UNITED STATES PATENT AND TRADEMARK OFFICE

APPLICATION NO.	FILING DATE	FIRST NAMED INVENTOR	ATTORNEY DOCKET NO.	CONFIRMATION NO	
10/690,421	10/20/2003	Steven S. Larsen	PLARSS 3835		
7590 08/01/2006			EXAMINER		
Thompson E. Fehr			DONAHOE, CASEY D		
Suite 300 Goldenwest Corporate Center			ART UNIT	PAPER NUMBER	
5025 Adams Avenue			3732		
Ogden, UT 8	4403		DATE MAILED: 08/01/2006	DATE MAILED: 08/01/2006

DETAILED ACTION

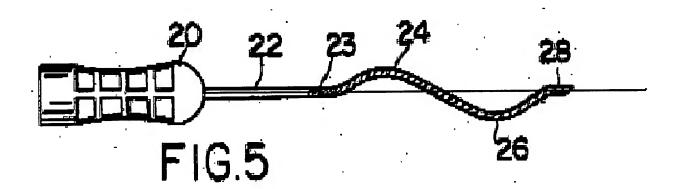
Furthermore, Applicant attempts to distinguish the endodontic file of the present invention from that of Lovaas by stating that the file only crosses the centerline once. However, as can be seen from the drawing below, the file of Lovaas only crosses the center line once then barely returns to the centerline without crossing it again.
